OXFORDSHIRE COUNTY COUNCIL'S RESPONSE TO CONSULTATION ON THE FOLLOWING DEVELOPMENT PROPOSAL

District: Cherwell Application no: 22/01682/F

Proposal: Development of a ground mounted solar farm incorporating the installation of solar PV panels, associated infrastructure and access, as well as landscape planting and designated ecological enhancement areas.

Location: Land North Of Manor Farm, Noke

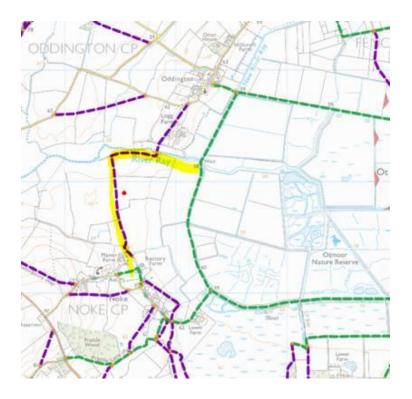
This development affects public rights of way. Standard measures below will apply. In addition, a request is made for the development to provide a permissive or definitive upgrade for the footpath by providing yellow route below as a bridleway to enable more riding access to Otmoor.
